RICHMOND COMMUNITY SCHOOL
Richmond High School: Mechanical Modernization Project
LWC Commission No. 20104.02

ADDENDUM #03
October 3, 2021

Comm. No.	Date	20104.02	08.27.2021
Drawn	Drawing No.	NGM	E205
Checked		JAE

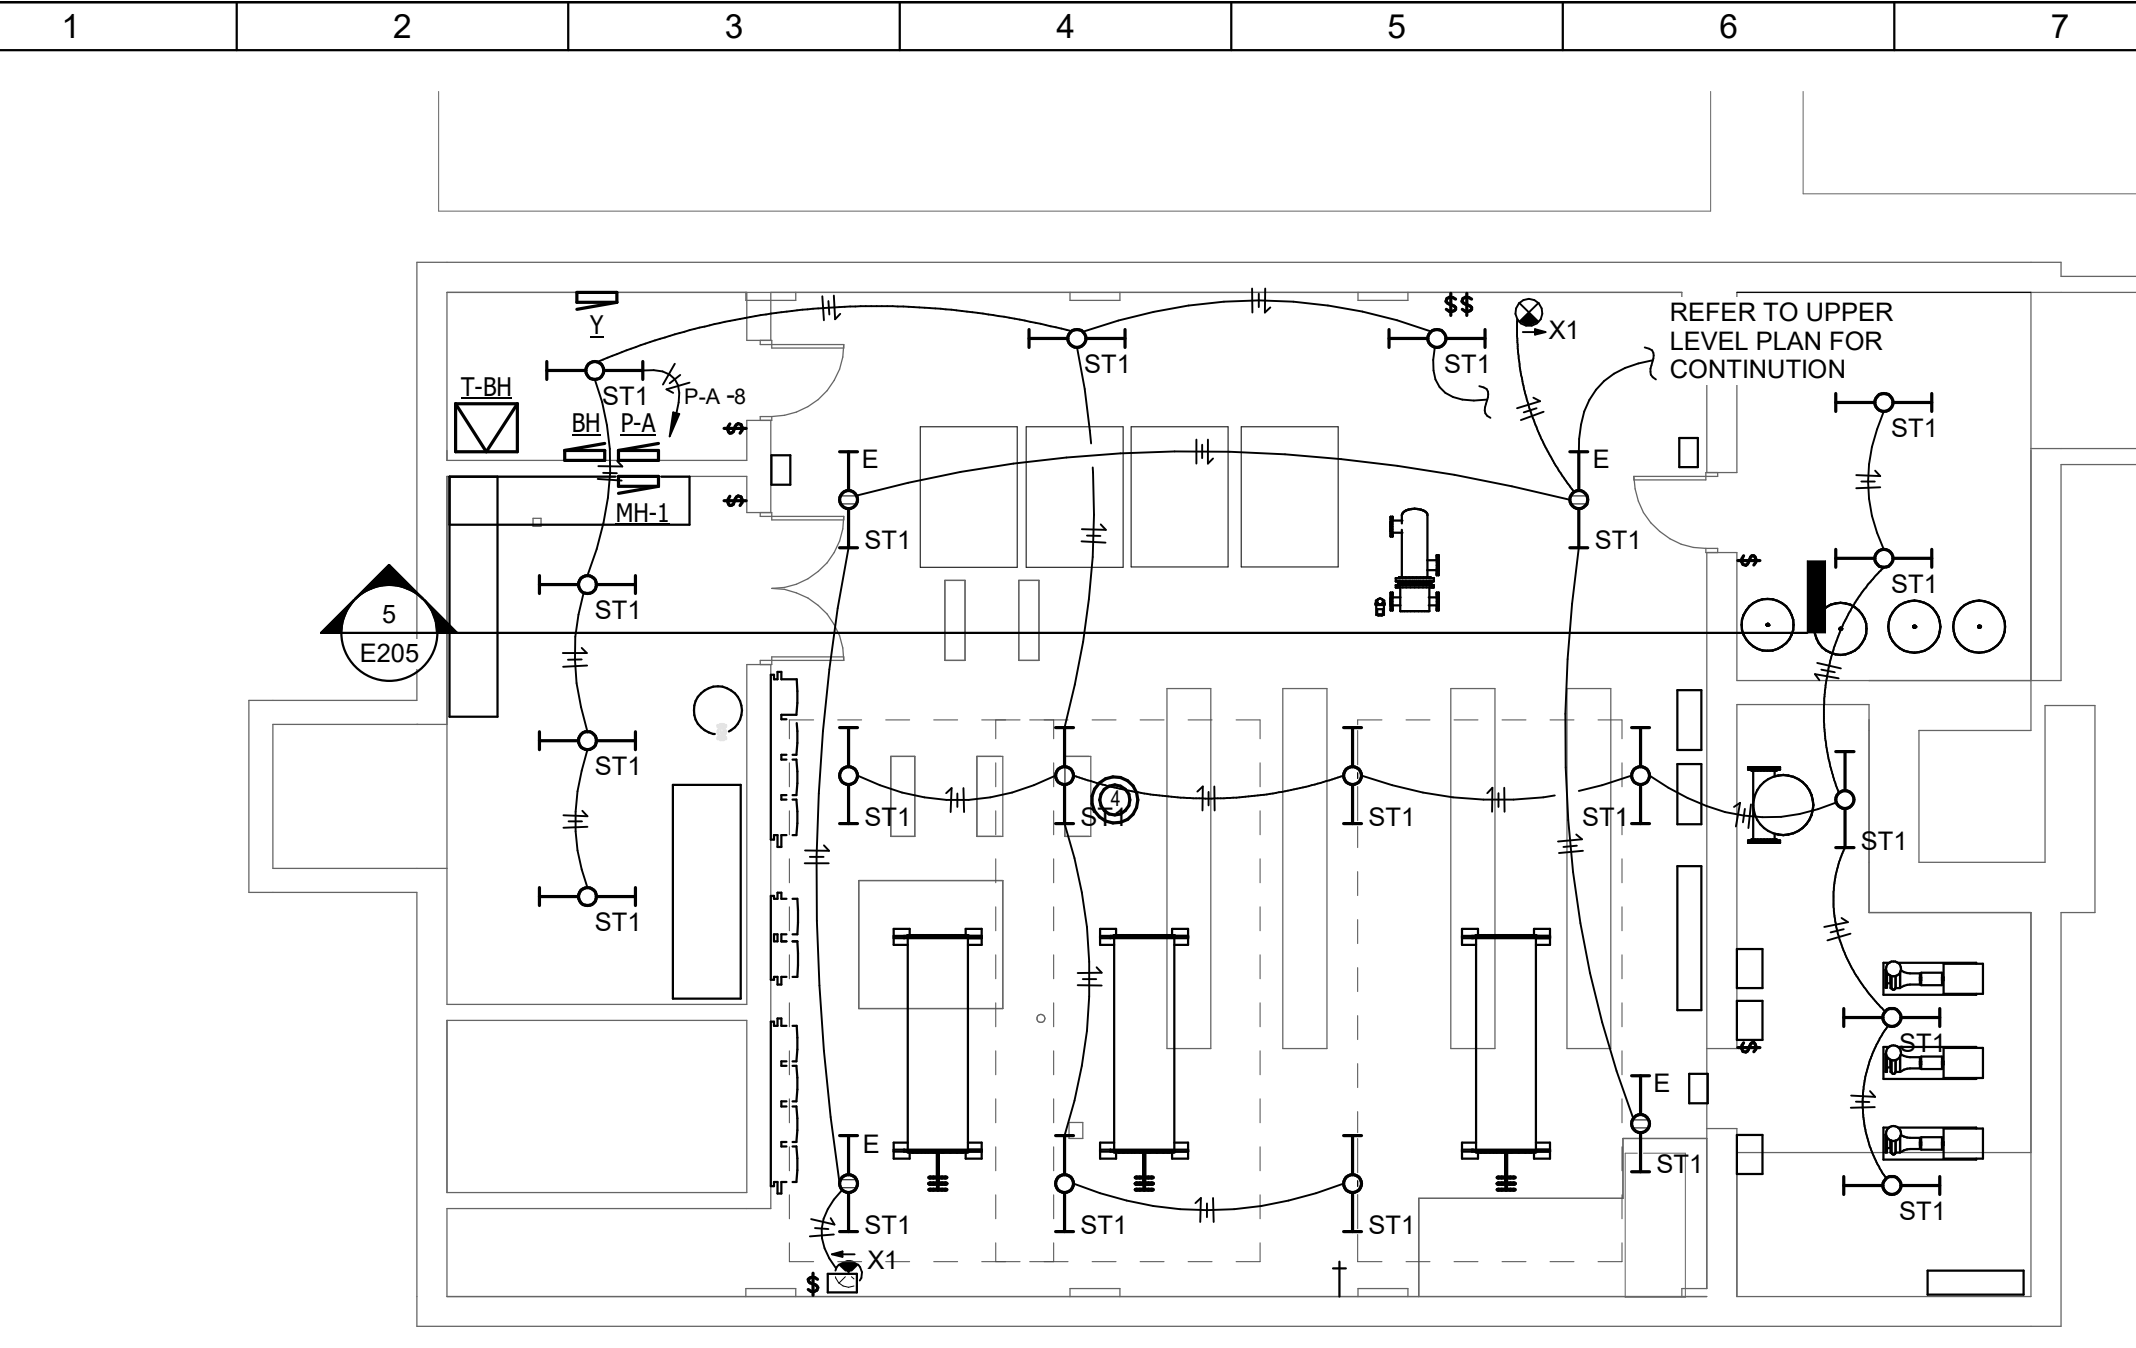
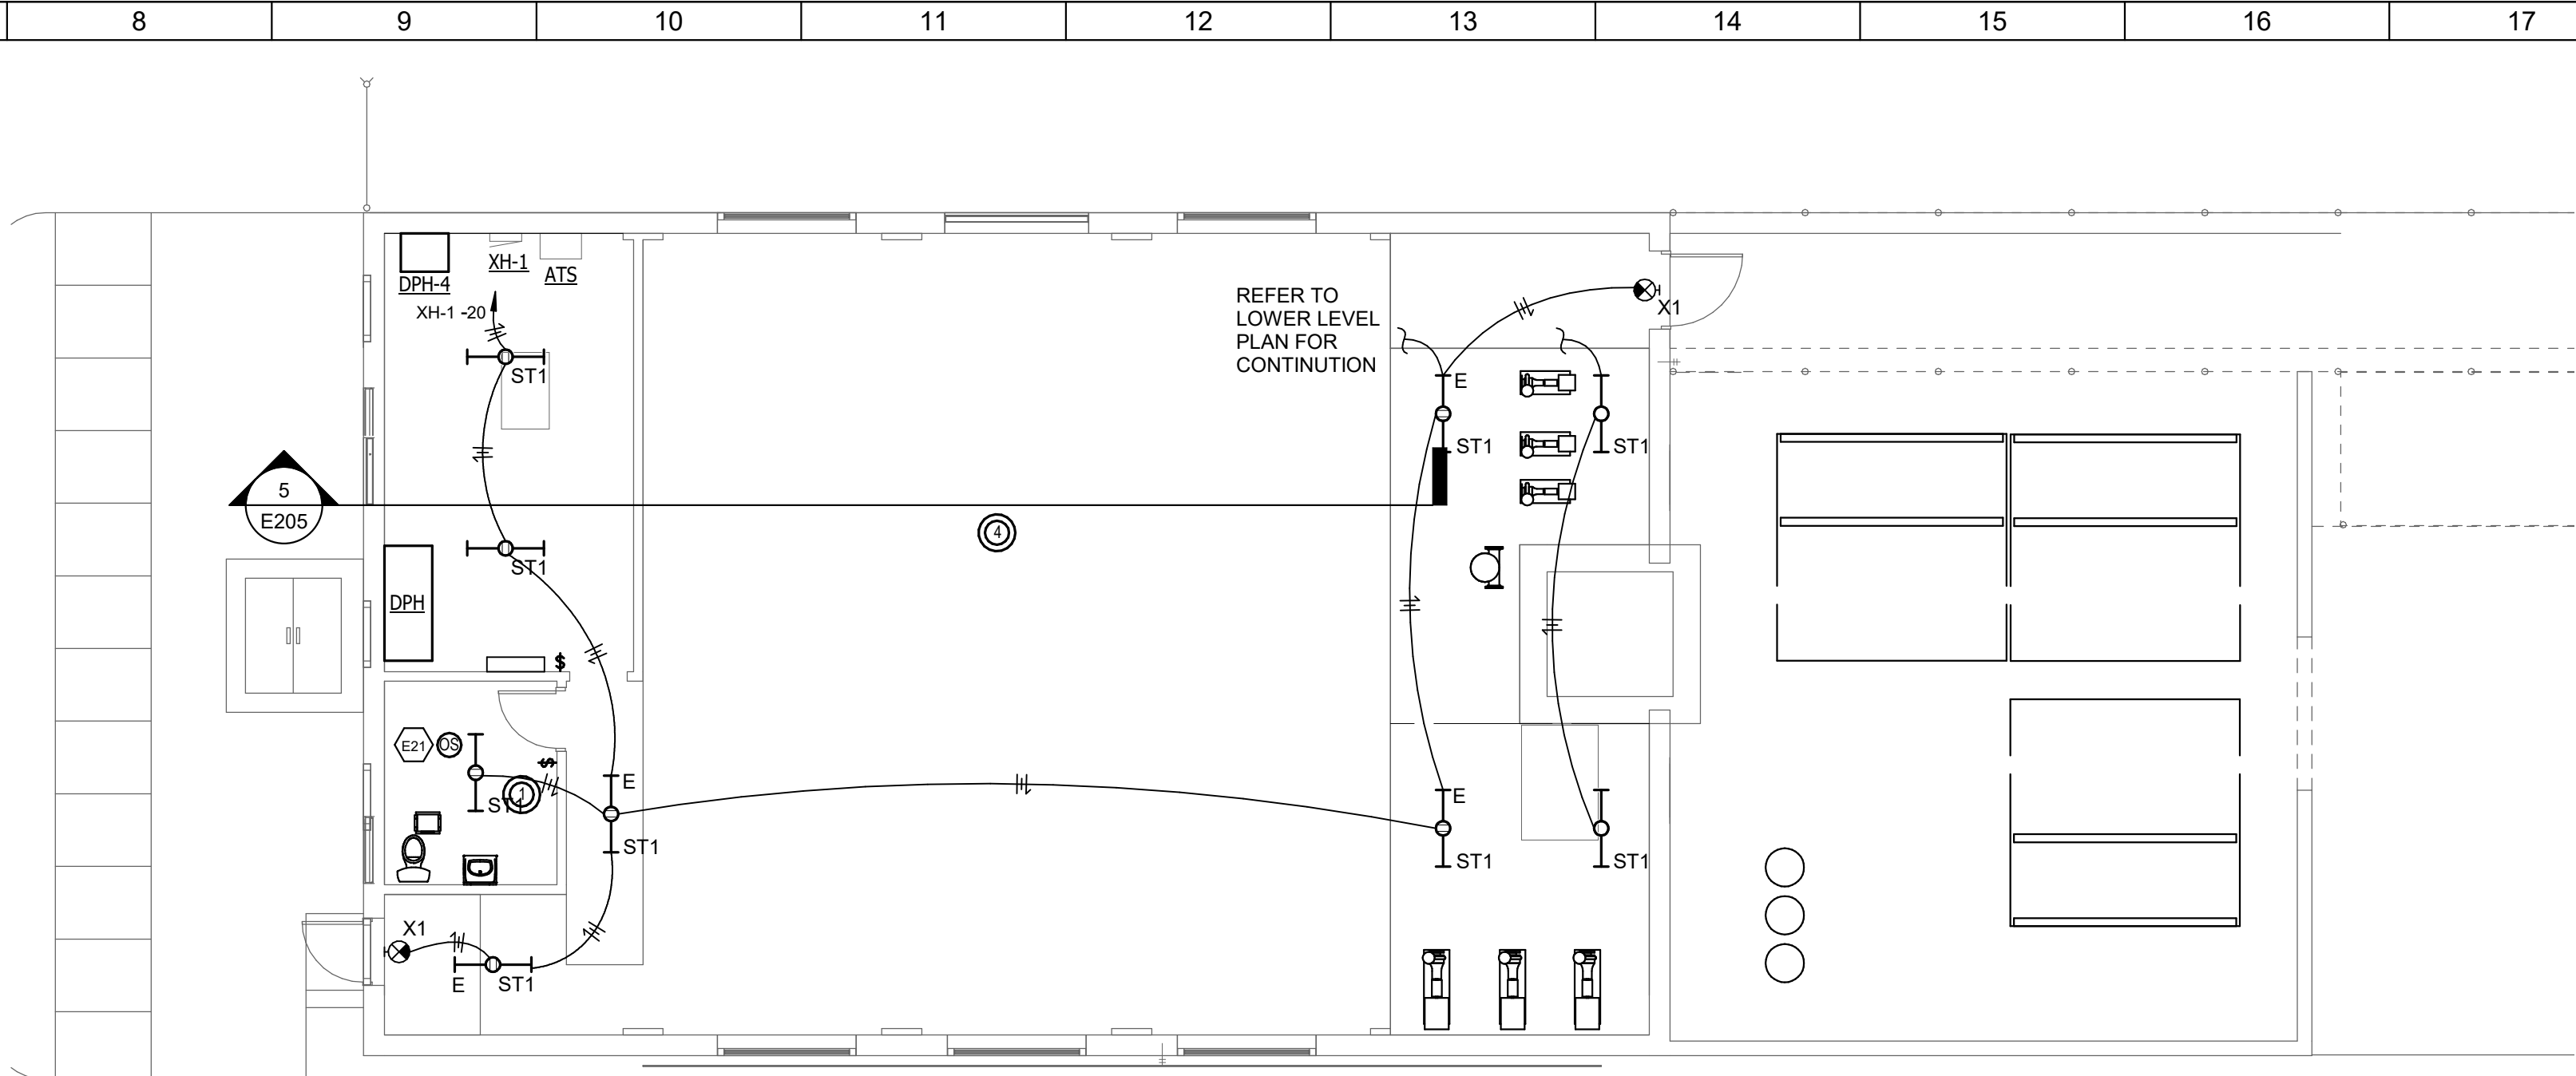
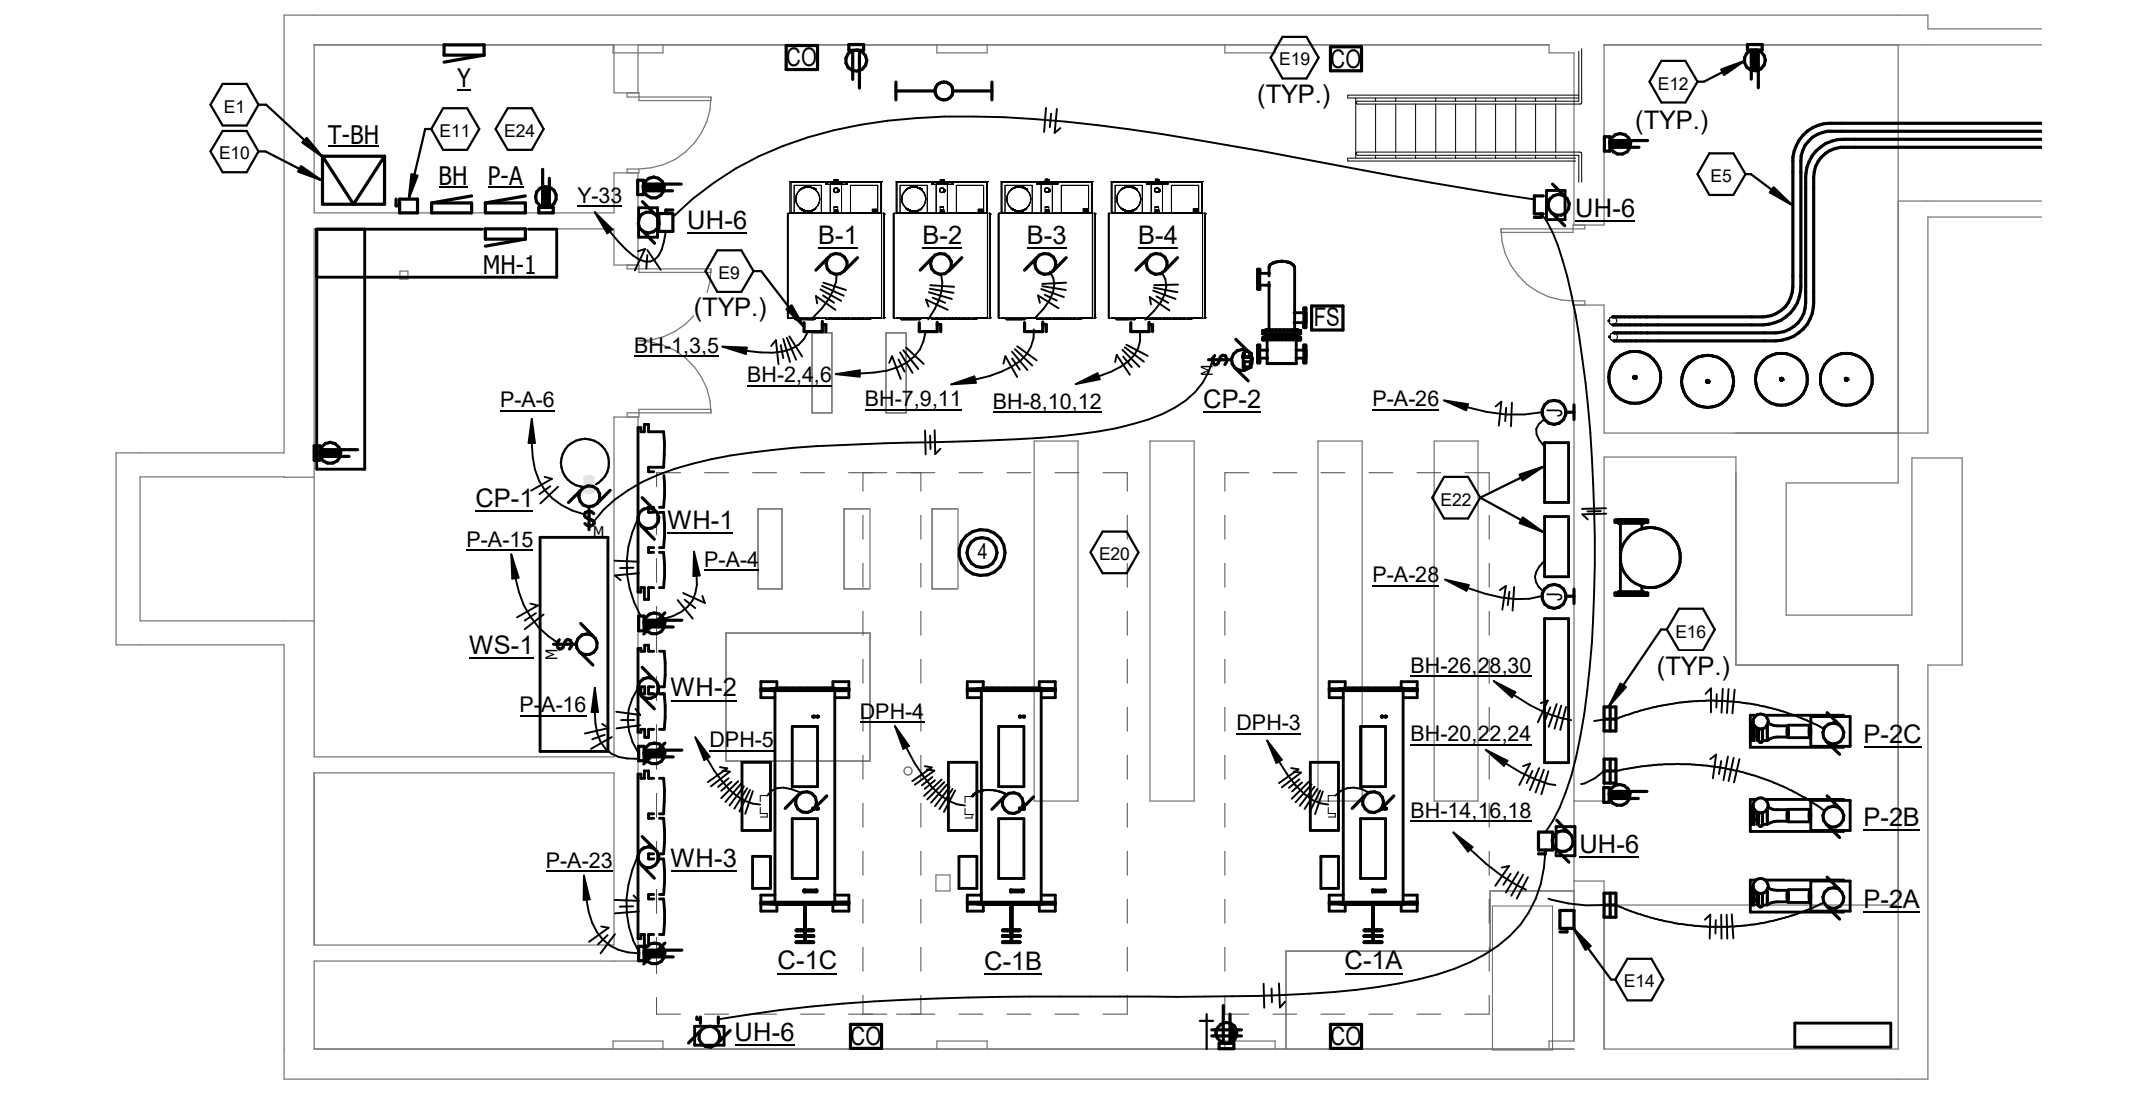
ITEM NO.12 Drawing E205
